Agenda
City of Springboro Planning Commission Meeting
Wednesday, March 8, 2023, 6:00 p.m.
Council Chambers, City Building, 320 West Central Avenue

Site Plan Review, 800 West Central Avenue (SR 73), proposed Sheetz fuel center, convenience store/restaurant

Site Plan Review, 25 West Central Avenue (SR 73), new bank branch for River Valley Credit Union

PLANTING PLAN

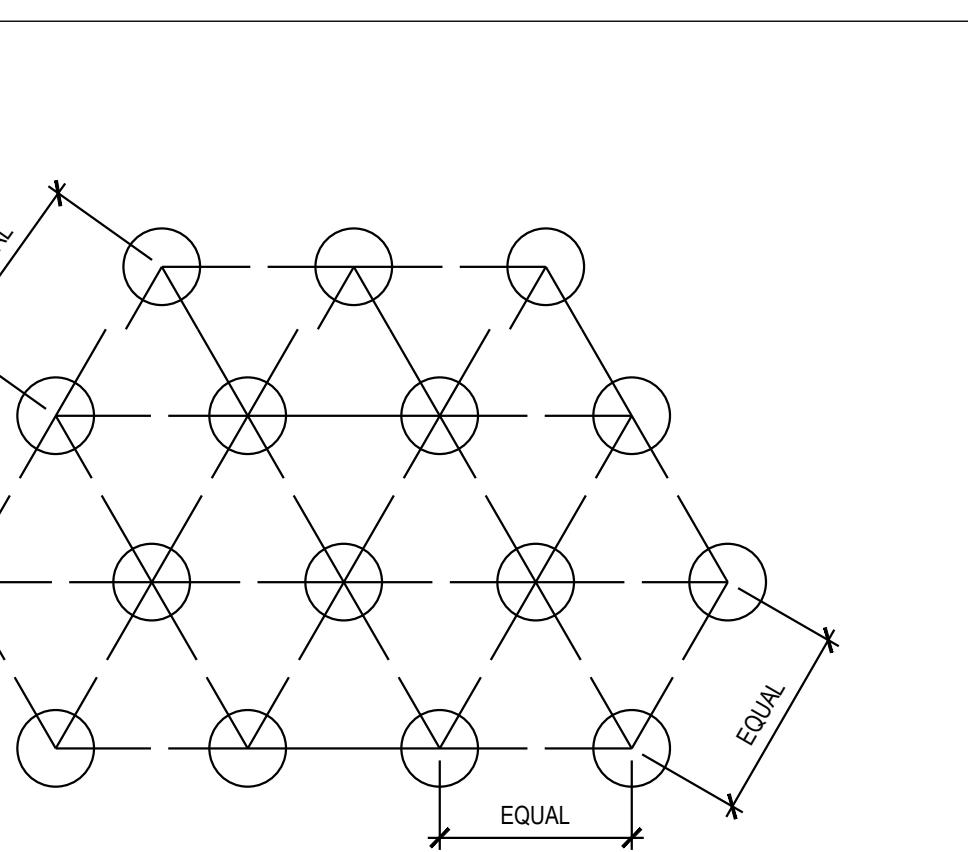
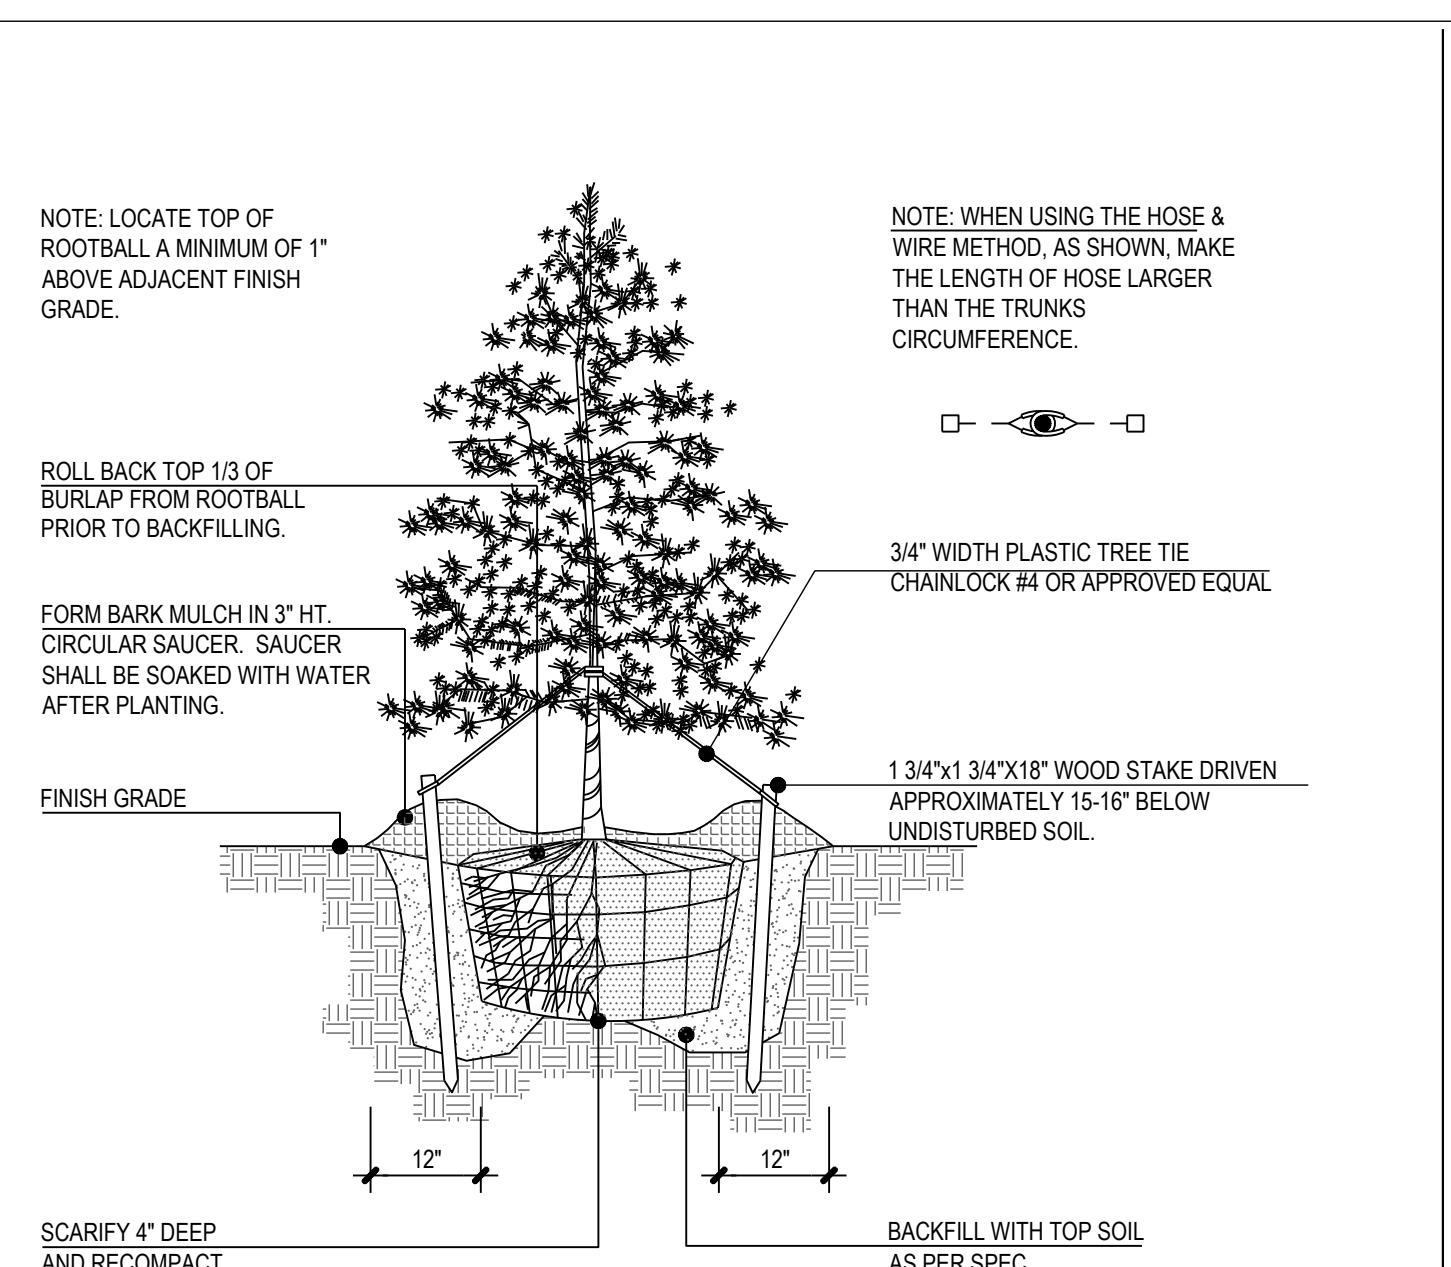
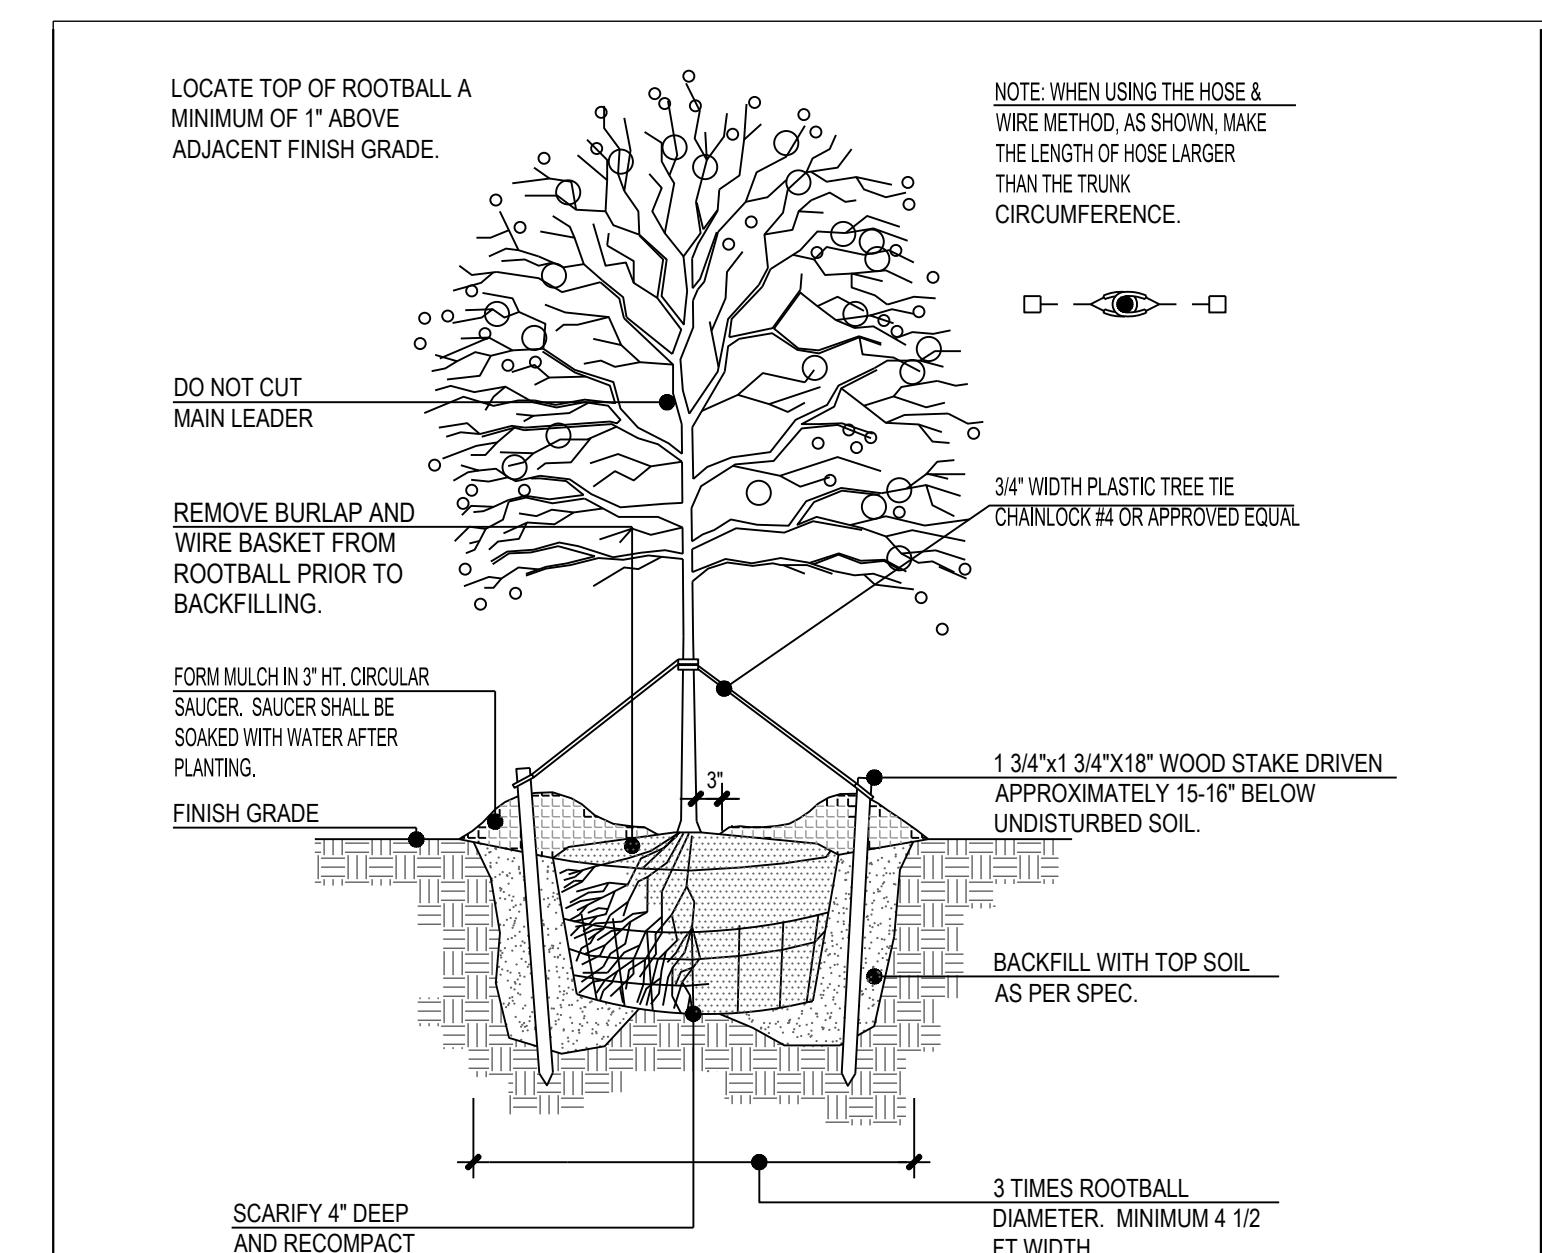
- g. Average to maximum (4:1 permitted) and minimum to maximum (10:1) ratio are exceeded on the photometric analysis. Revise plan accordingly.
2. For proposed landscaping plan (sheets L1.0-1.1) address the following:

- a. Additional landscape treatments needed to lessen impact of fueling center portion of proposal on West Central Avenue frontage in the form of mounding, screen wall or fencing as discussed at October 12th Planning Commission meeting. See also Tahlequah Trail landscaping comment.

- b. Provide a total of 5 shade trees on West Central Avenue frontage (5 required, 2 indicated in notes, 3 shown on plans).
 - c. Adjust landscape arrangement on Tahlequah Trail frontage to include shade trees on southwest corner of site. Also, proposed cherry trees are not acceptable as shade trees for this application (may be used to satisfy ornamental and other tree requirements).

- d. Indicate parking lot landscape areas noted on sheet L1.0 and location of 11 proposed trees.
 - e. Are no landscaped areas proposed on the south side of the c-store/restaurant?
